TAL-CO SUPPLEMENTAL INSTRUCTION #10			
Project Name:	RW TOMLINSON - NEW HEAD OFFICE		
Project Location:	100 Nortel Drive, Ottawa, Ontario		
ARCH. SI #:	ASK-4	Issued By:	Chris Simpson
STRUC. SI #:	SSI #008	Date Issued:	October 12, 2016
MECH. SI #:	N/A	Revision #:	N/A
ELEC. SI #:	N/A	Revision Date:	N/A

Title: Typical Half Wall/ Millwork Support Detail

STRUCTURAL SITE INSTRUCTION

STRUCTURAL SITE INSTRUCTION No.: 008

12 TYPICAL HALF WALL DETAIL
 A604 SCALE = 1:10

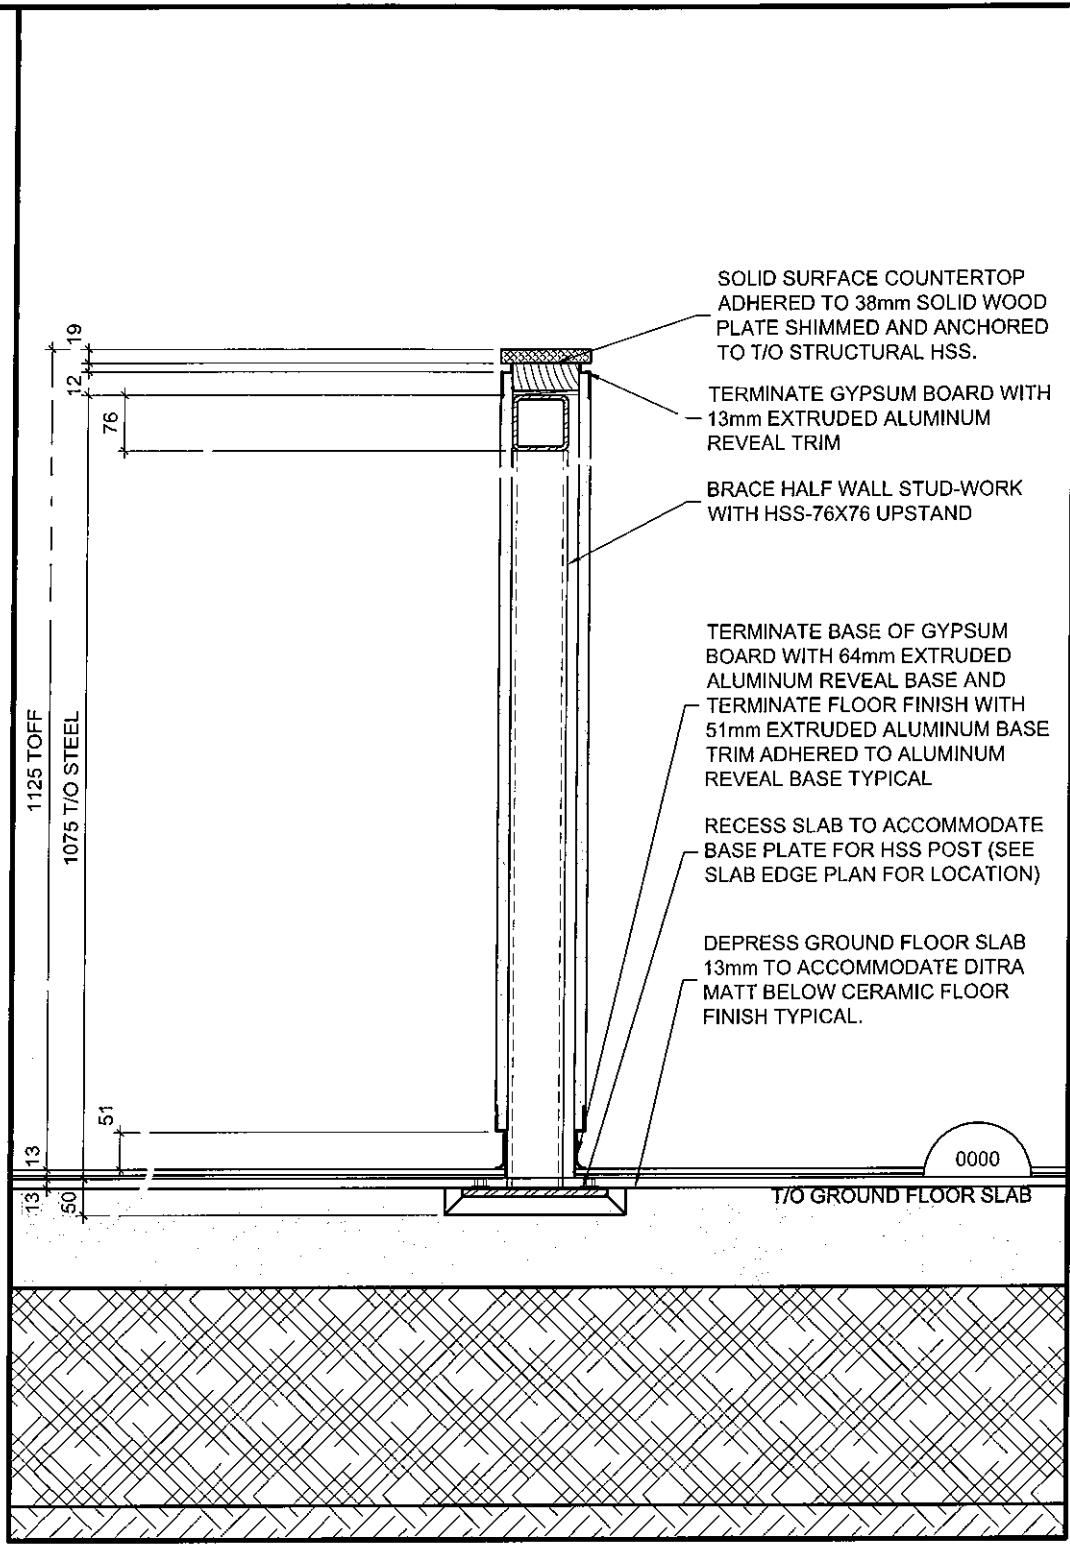
Description of the Work: Provide steel support structures as per attached for free standing millwork/ half walls (located in ground floor cafeteria/ 2nd, 3rd, 4th, floor staff kitchens). Recess floor to accept base plates in these locations (see slab edge drawings for locations).

Reason: Structural support required for half walls, kitchen islands. Base plates recessed to conceal plate and anchors.
